Diesel Land Rover Pre - 1983

Instructions for changing Land Rover hair pin series wired glow plugs to parallel wired probe type glow plugs.

Fig 1.1 - Existing System

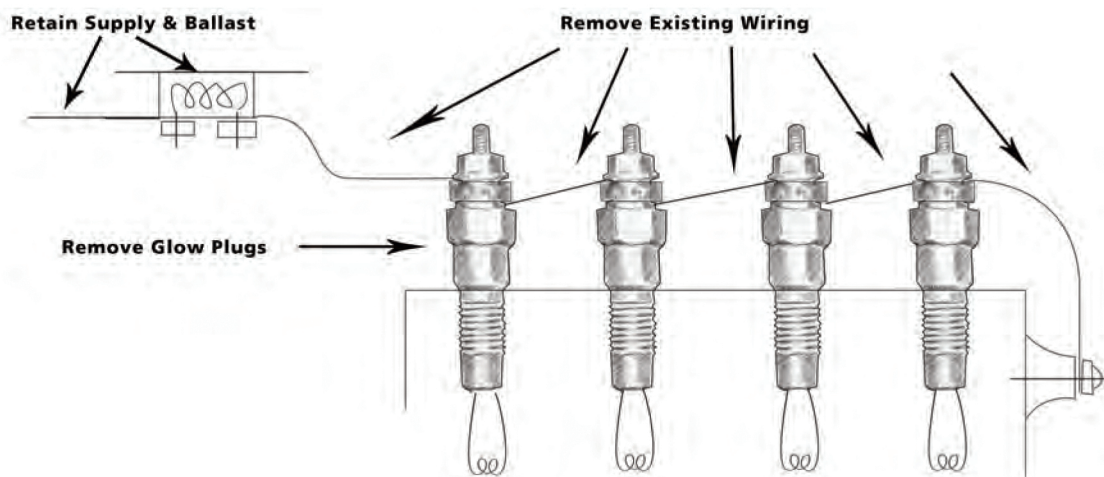
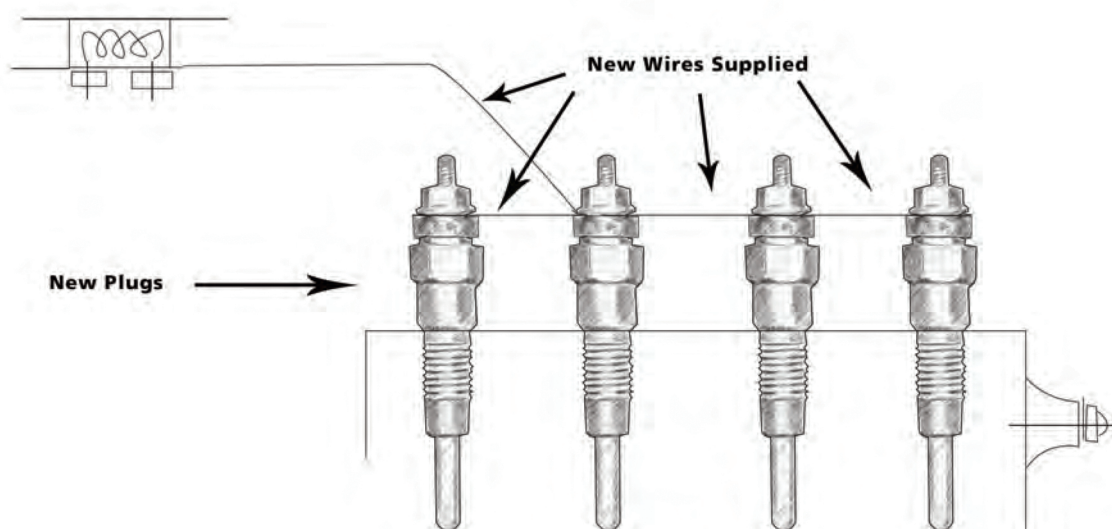
- 1) Remove existing wiring between ballast resistor and glow plugs also between glow plug and earth discard. (fig 1.1)
- 2) Remove existing hair pin type glow plugs from engine and discard
- 3) Fit new probe type glow plugs to engine, tighten to recommended torque.
- 4) Using new wiring supplied, wire glow plugs and ballast resistor as per fig 1.2, care should be taken to ensure that all terminal nuts are properly tightened.
- 5) Start engine using normal method.
